ORAL HEARING

RESOURCE RECOVERY CENTRE,
RINGASKIDDY, COUNTY CORK

WITNESS STATEMENT OF JULIE ASCOOP

COASTAL EROSION

Figure 1: Typical slope failure showing circular slip surface

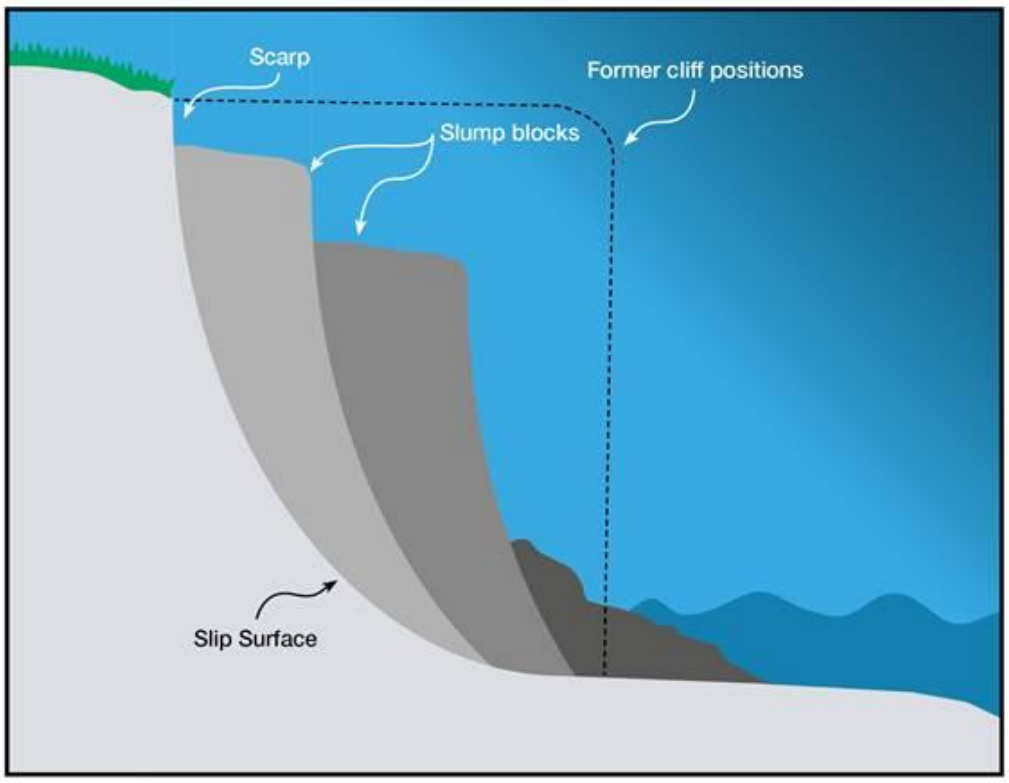
The presence of sand deposits, and the less steeper angle (compared to the slope of the face where failure had not occurred) or more circular slip surface (see image below), with significant flow of water through the face of the slips observed at the failure zones, all point in this direction.

There is no evidence that one mechanism makes a greater contribution than the other. As shown in the image above, Figure 1, the geotechnical slope failure is likely to cause a bigger slip circle but would occur less frequently than the smaller slides caused by the 'notching' of the cliffs due to wave action.

Figure 2. Typical steepened cliffs eroded by wave action

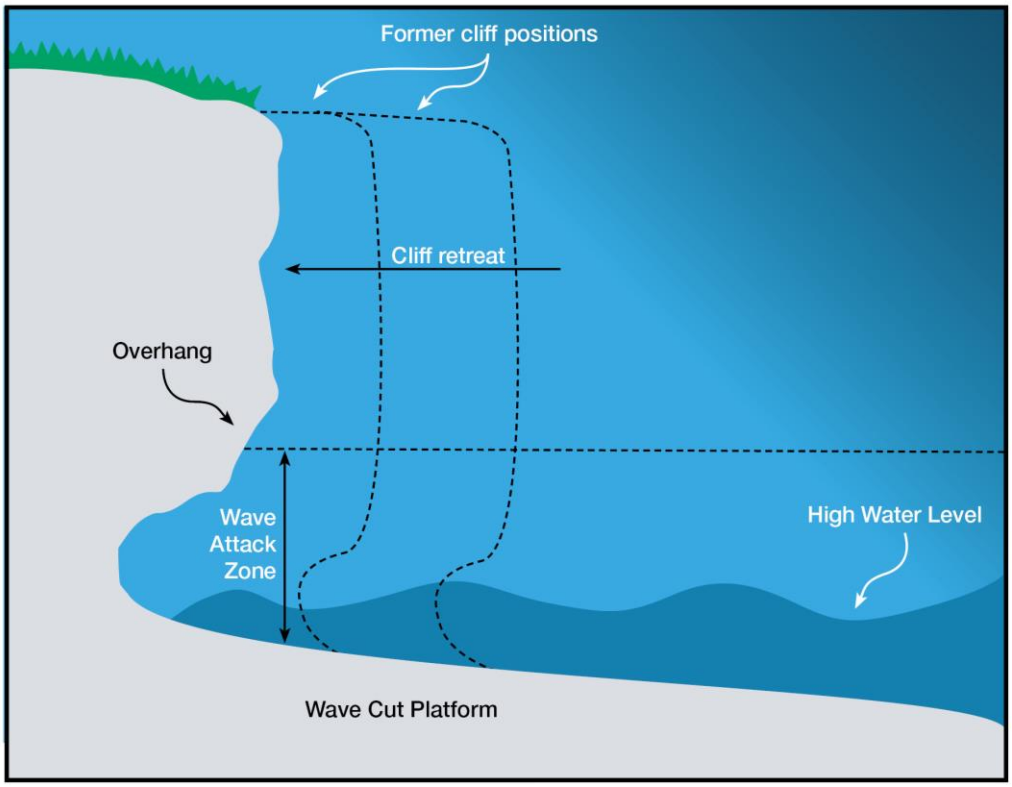
The December 2015 failure confirms the assessment (see Appendix 13.3 of the EIS) that the cliff recession has both a geotechnical and a coastal element. The coastal impact was confirmed by our numerical wave modelling studies and wave run- up assessment which show that waves reach the bottom of the cliffs. We also have seen evidence on site of typical 'notching' of the cliffs caused by wave attack (see figure 2 and 3 below).

Appendix 1

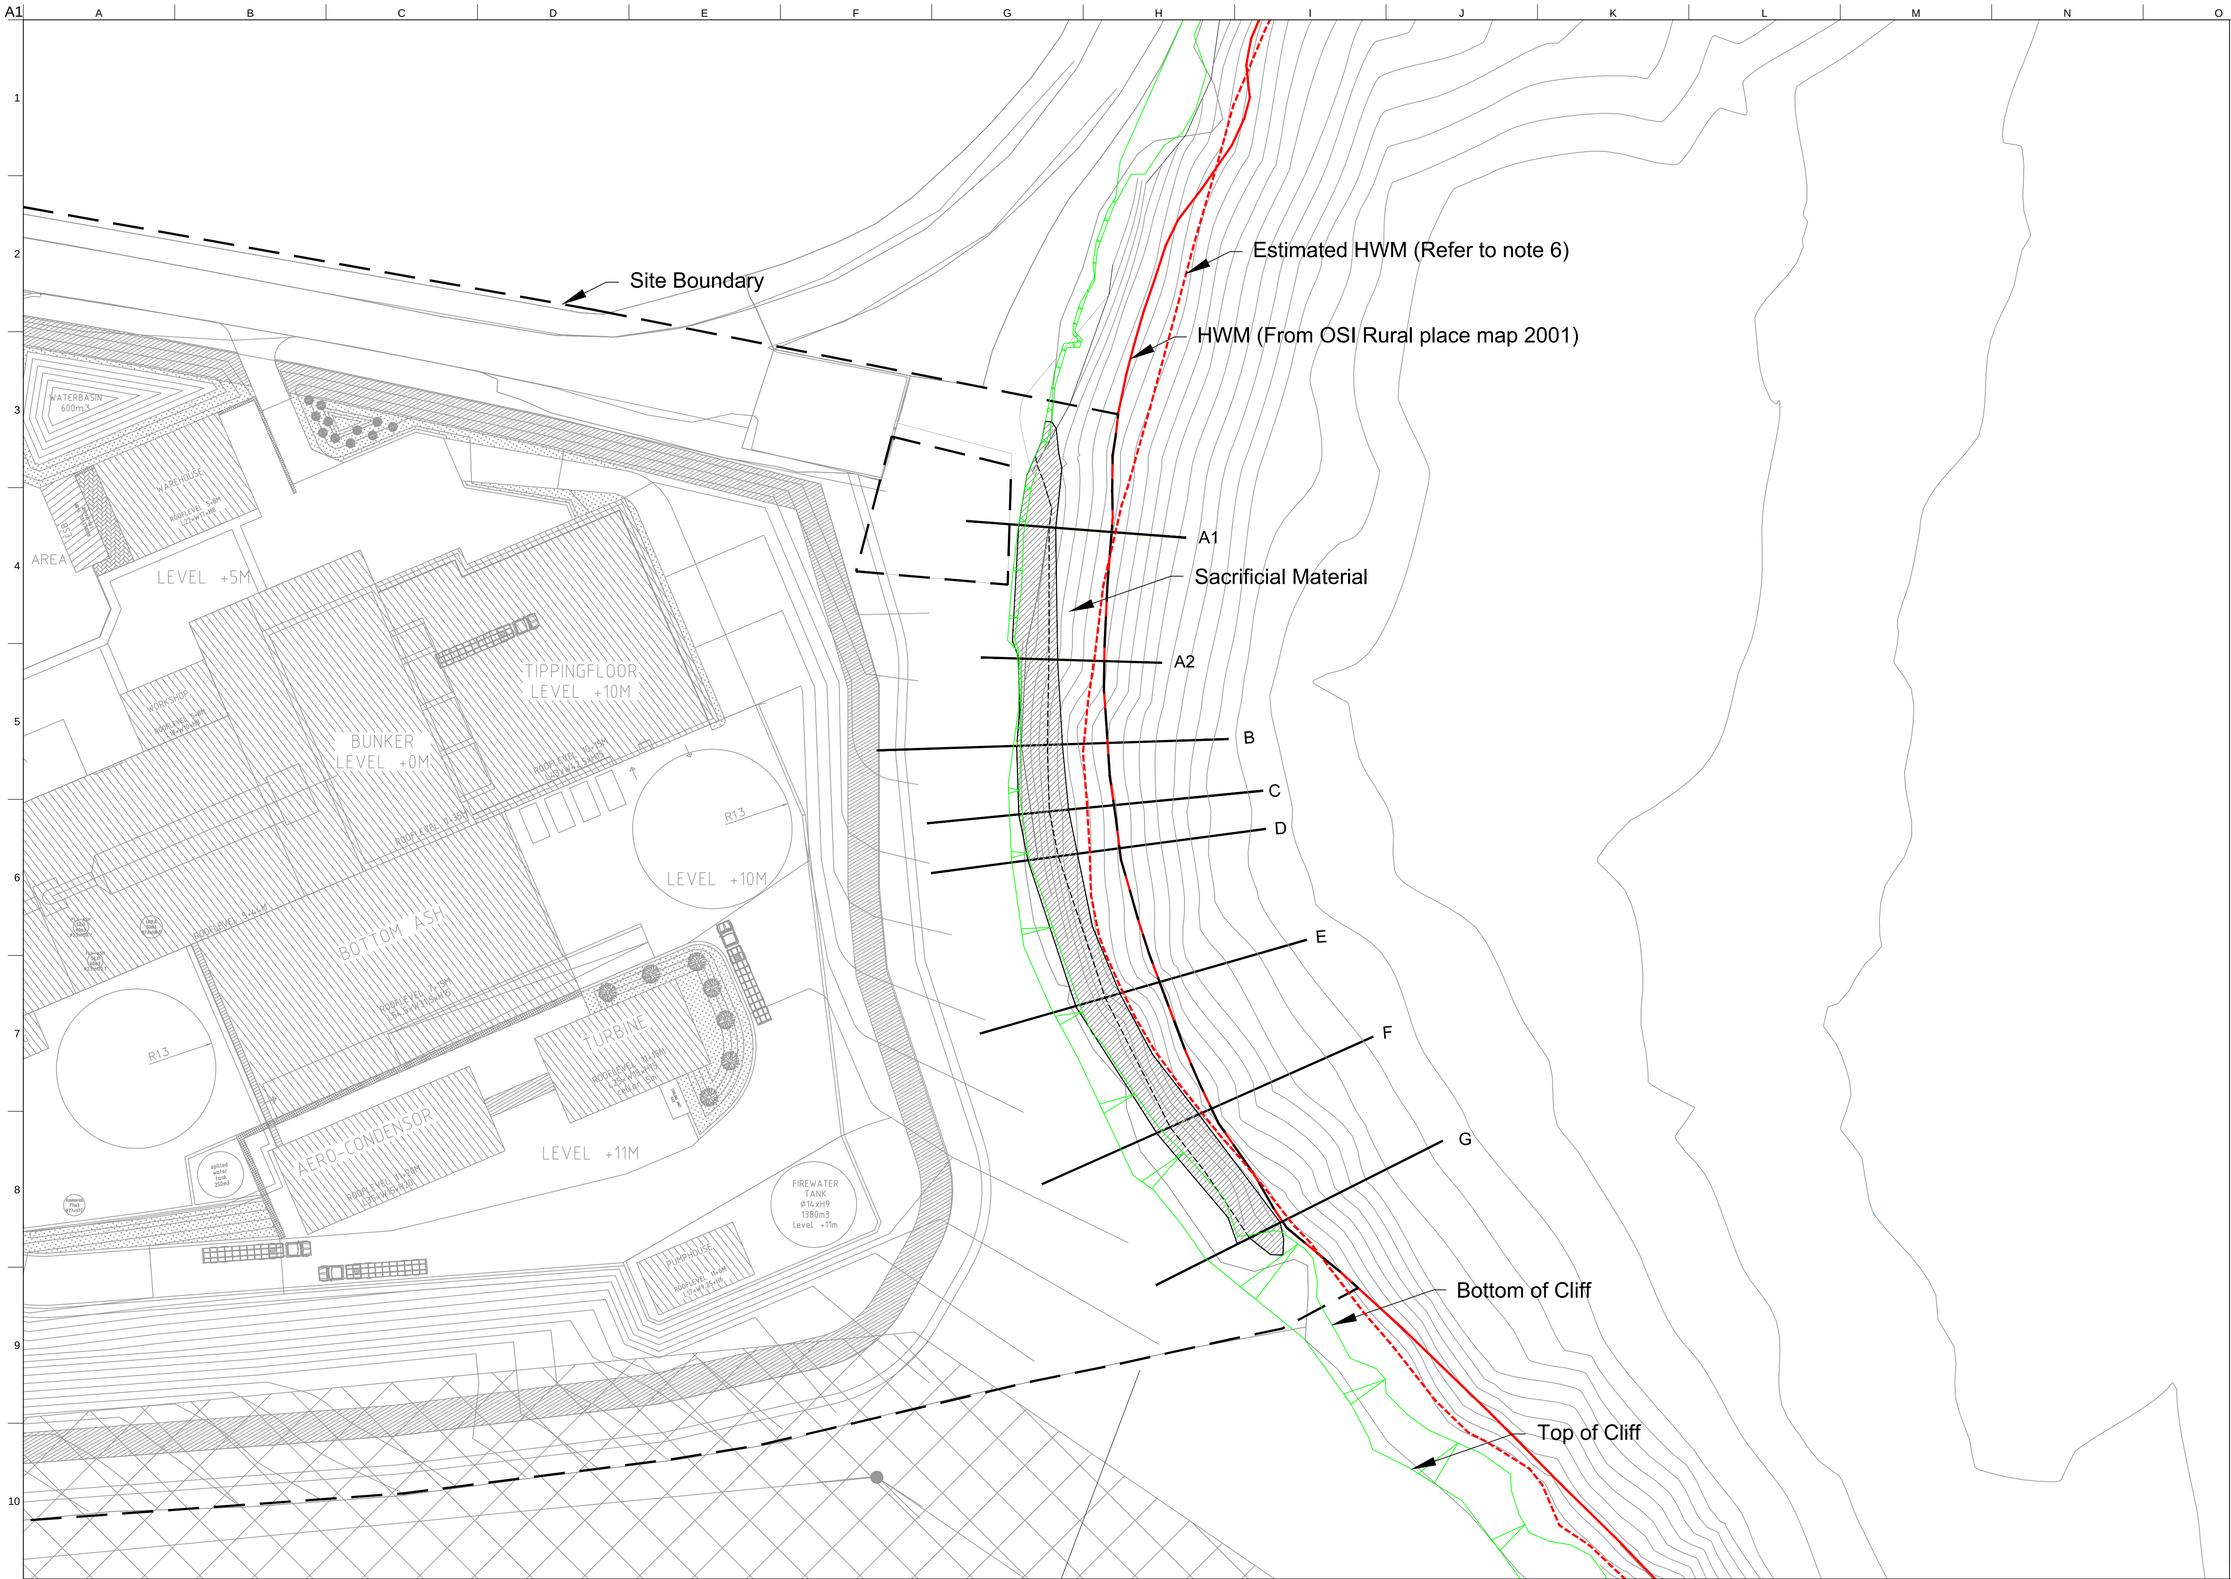
Submission:
Regarding the protection works planned to help slow the natural coastal erosion occurring at the seaside of the site, the submissions from the Cork Harbour Alliance for a Safe Environment (CHASE) and An Taisce have suggested that the high water mark at Gobby beach is moving into the site, so it would be impossible to work without placing materials on the foreshore.

In reality the HWM changes constantly due to natural variations in the level and slope of the coastal areas. The HWM moves seawards and landwards for example during and between storm events). However, Ordnance Survey Ireland informed us that the HWM on the OSI map remains in the same position on each map revision. We will consult further with DoE before carrying out the works. If it concludes that that the proposed works might affect the foreshore as determined at the relevant time, then then the amount and position of the sacrificial material can be adjusted to remain above the HWM as shown in Appendix 1 of this document.

Appendix 1 shows an estimated current HWM with a reduced amount of sacrificial material above this HWM. The reduced amount would increase the frequency of application slightly, but this still falls within the impacts appraised within the EIS.

Appendix 2

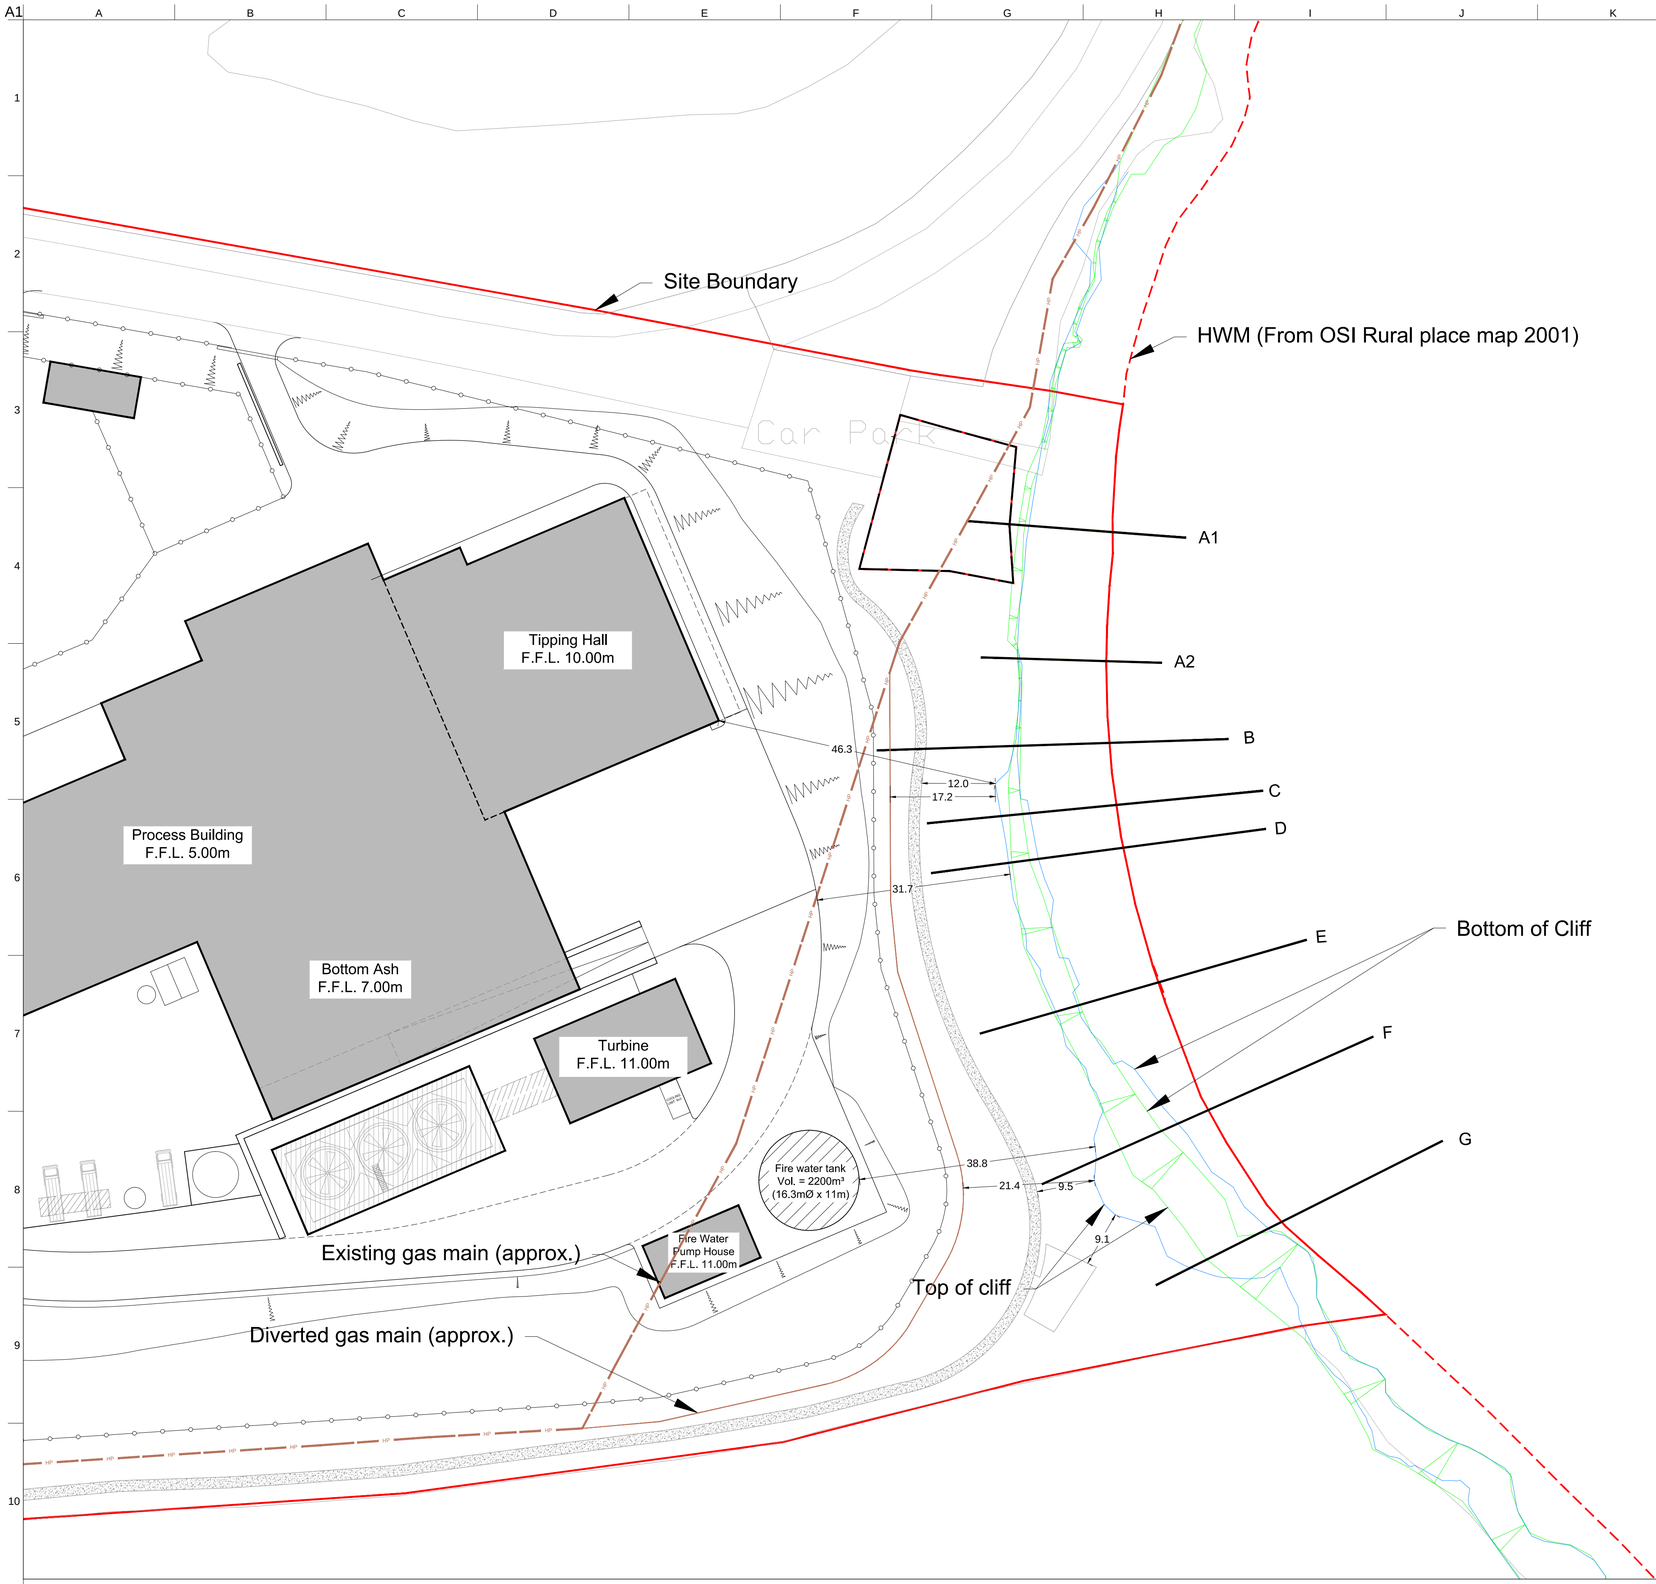
Submission:
The submission from Cork County Council asks for clarification on the coastal retreat rate estimation following import placing of beach nourishment shingle.
Cork County Council suggests the applicant should be requested to outline the distance of the proposed facility from the current cliff face, amenity walk and diverted gas line.

Response:
The estimation of coastal retreat following import placement of beach nourishment shingle has been provided in the EIS (see Appendix A of Appendix 13.3 of the EIS).
The minimum distance from the worst section of the current top of the cliff to the building is 46m. Distances to all other key elements are provided in the Appendix 2 of this document.
